DATE: 3.14.2017
TO: ProTrak
FROM: Bill McDow
Transportation Planning

■ **THE WOODLANDS AT ECHO FARMS DEVELOPMENT [TRC Plan Review #2]**

↻ Initial Review Note ↻

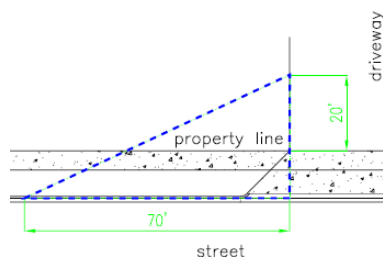
1. The proposed Street L requires sidewalk on both sides of the street per SRB conditions for sidewalk on both sides of proposed streets.
2. The proposed Street U requires sidewalk on both sides of the street per SRB conditions for sidewalk on both sides of proposed streets. The Sidewalk on this street appears to end prior to the final three lots #52- #54.

3. Several plan sheets show an unnamed street that services lots #26 to #31. Provide a name for this 6 lot street. [7-5 CofW Tech Stds]
4. Provide street names for all proposed streets. Contact Jim Sahlie, PE for street name approval.

5. The current sheets do not show all the streets around Tracts 3A and 3C.
6. Show a pavement cross section for the proposed streets.
7. Please address the previously stated centerline distances. The project appears to have intersections that are closer than the required 200'/400' minimum distance between

centerlines, per the City's technical standards. [7-5 CofW Tech Stds] The intersections with centerline distances less than 400' include:

- (a) All streets in Tract 3C, such as Road P and adjacent streets.
 - (b) Intersection of St Anne's Moor and entrance street to Tract 3C.
 - (c) Intersection of Road J and Foxhall Court.

- (d) Intersection of Road E and Belfairs Drive/Appleton Way Roundabout.
 - (e) Intersection of Road T and Independence Blvd.
8. Street M has a R160' horizontal centerline radius, which is less than the minimum of 200' for collector streets.
